**Spark Architecture**  
Sophia Sparklin, AIA  
410 Central Ave #506  
Great Falls, MT 59401

<b>Subject</b>	<b>Project ID#20011</b>	<b>DATE</b>
<b>Addendum #3</b> Clarify wall section call-outs	<b>Big Springs Trout Hatchery Residence #2035 Replacement</b>	2022.02.23

b. **SKA 2, 2/23/22: Revised Details 3&4/A602**

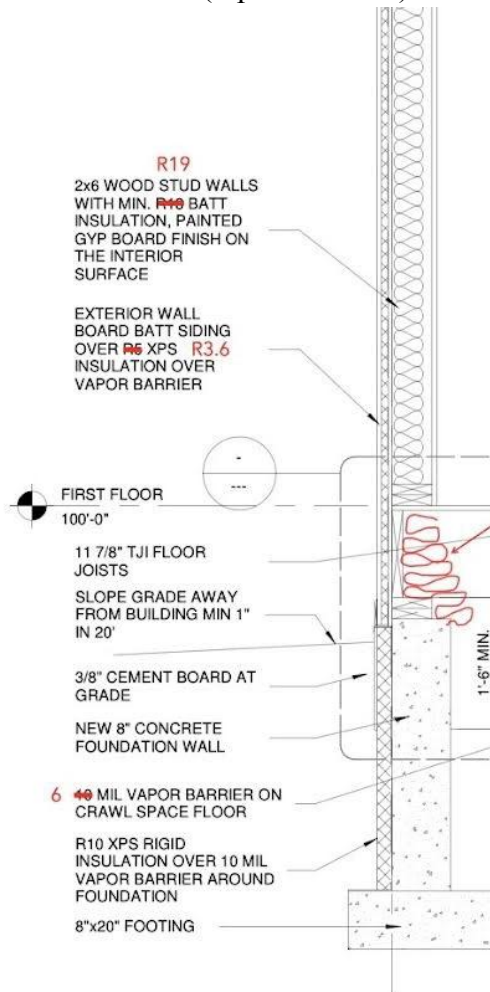
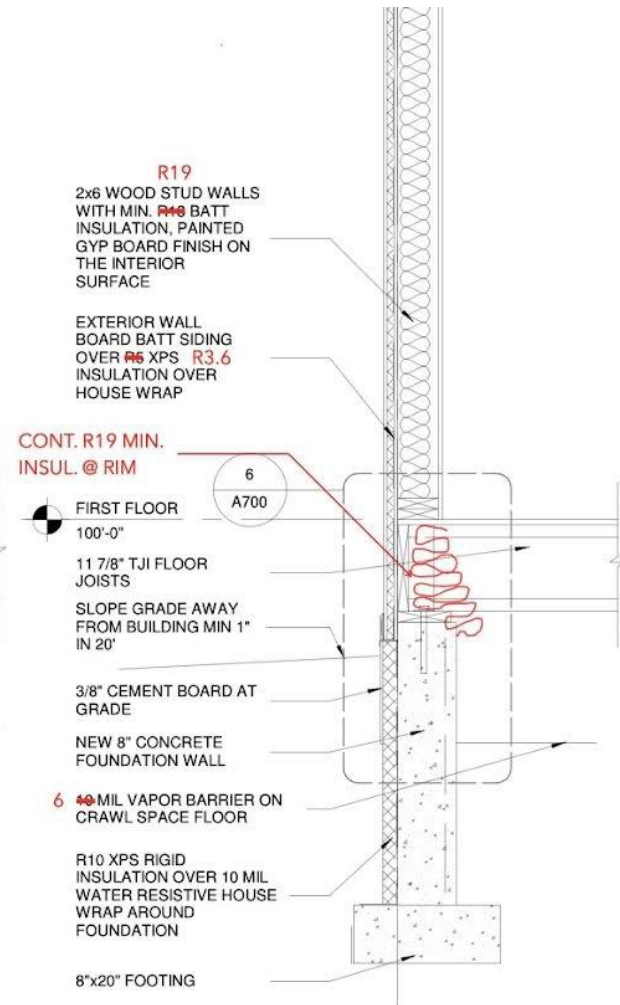
*Includes corrected information for Wall Sections to match info on A101/w1 wall type, and Details 5,6/A700:*

- i. Use min R19 Batt (Replace R10).
- ii. Use min R3.6 xps. (Replace R5)
- iii. Use min R19 insul. @ Rim
- iv. Use 6 Mil (replace 10 Mil)
